**aerosmith ST4100**

**ST4100-01**

**INSTALLATION INSTRUCTION FOR SEQUENTIAL TRIP CONVERSION KIT (CN81097)**

<Current Installation Instruction>

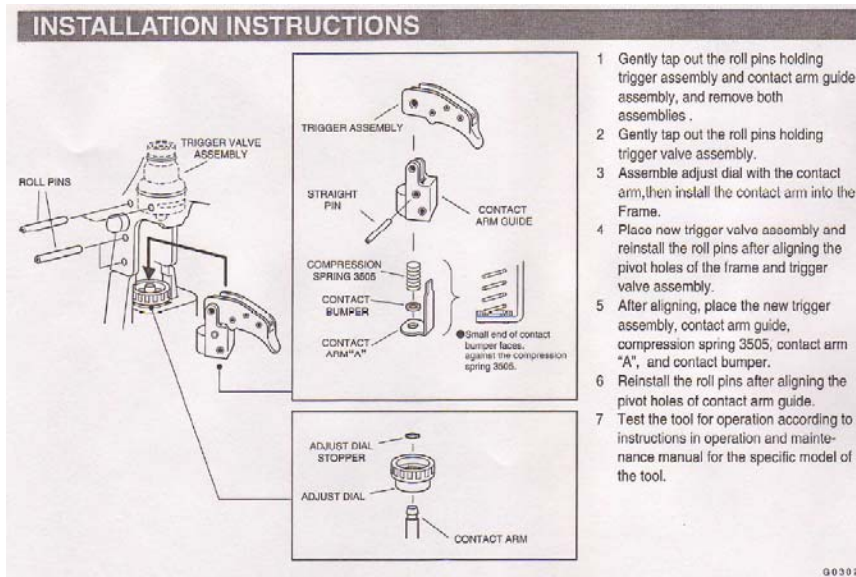
To obtain correct action of Sequential Trigger, it is necessary to remove Spring 3130 (KK23130) and Spring 3189 (KK33189) before reassembly of Conversion kit. INSTALLATION INSTRUCTION has been revised.

**Remove SPRING 3130 and 3189 before reassembly Conversion kit.**
